**CENTERIOR
ENERGY**

Subject: Additional Information for Proposed Modification to the
Davis-Besse Nuclear Power Station (DBNPS), Unit Number 1, Facility
Operating License NPF-3, Appendix A Technical Specifications to
Revise Technical Specification 3.8.1.1 - A.C. Power Sources,
Operating

ADDITIONAL INFORMATION FOR PROPOSED MODIFICATION TO THE DAVIS-BESSE NUCLEAR POWER STATION, UNIT NUMBER 1, FACILITY OPERATING LICENSE NPF-3, APPENDIX A TECHNICAL SPECIFICATIONS, TO REVISE TECHNICAL SPECIFICATION 3.8.1.1 - A.C. POWER SOURCES, OPERATING (TAC No. M92532)

The questions below were provided by the NRC in its letter to Toledo Edison, dated November 22, 1995. Toledo Edison's response follows each question.

ONE LINE DIAGRAM
 345 KV SYSTEM

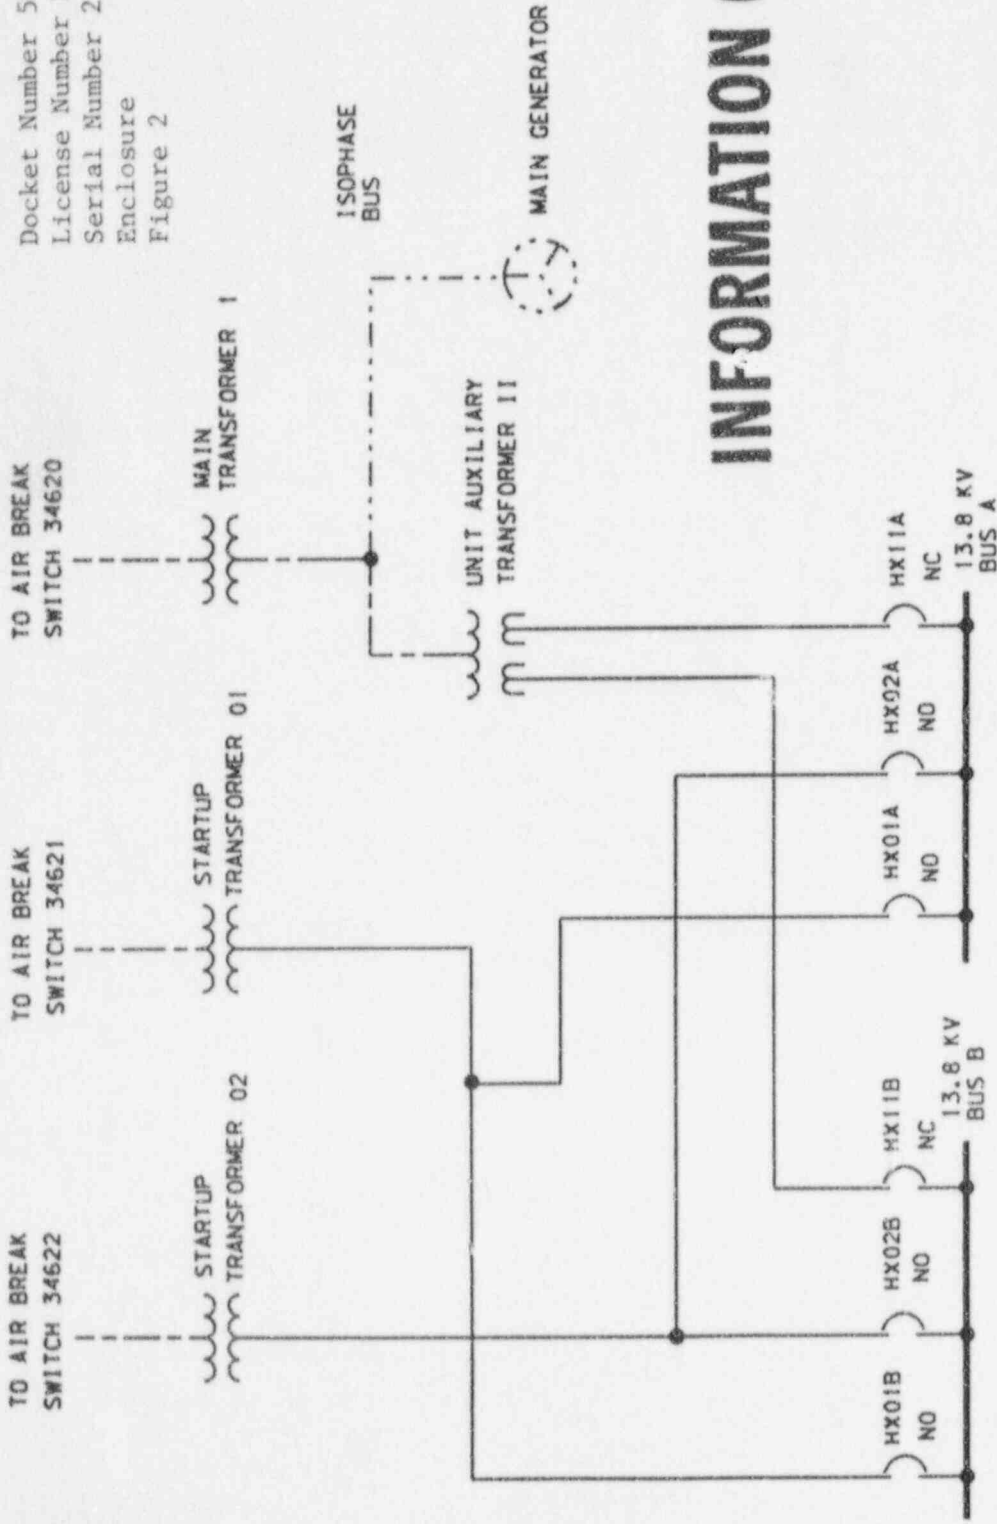
1. In your submittal of June 1, 1995, you stated that the transfer of a 13.8 kV bus between the three sources (i.e., three 345 kV lines) can be accomplished either manually or automatically. However, DBNPS Updated Final Safety Analysis Report (USAR) Section 8.3.1.1.2 states that automatic transfer occurs only from the normal to the reserve sources (i.e., the startup transformers) or between the two reserve power sources; the transfer from either of the startup transformers to the unit auxiliary transformer can only be done manually. Please describe how the third 345 kV power source (i.e., the unit auxiliary transformer) would become available to supply the 13.8 kV buses automatically in the event that both startup transformers would become inoperable. If the transfer can only be performed manually please provide an estimate of the time necessary to provide power to the 13.8 kV buses. Would the subject transfer be available in sufficient time following a loss of all onsite alternating current power supplies and the other offsite electric power circuits, to assure that specified acceptable fuel design limits and design conditions of the reactor coolant pressure boundary are not exceeded?

Three offsite powered 345 kV lines connect the Toledo Edison transmission grid to the 345 kV switchyard. The 345 kV switchyard design is a ring bus scheme with ultimate transition to a breaker-and-a-half scheme (see Figures 1, 2 and 3; provided for information only). Three overhead 345 kV lines are provided from the switchyard to the onsite station distribution system. Each circuit to the onsite distribution system is capable of carrying full station auxiliary loads assuming the other two circuits are not functioning.
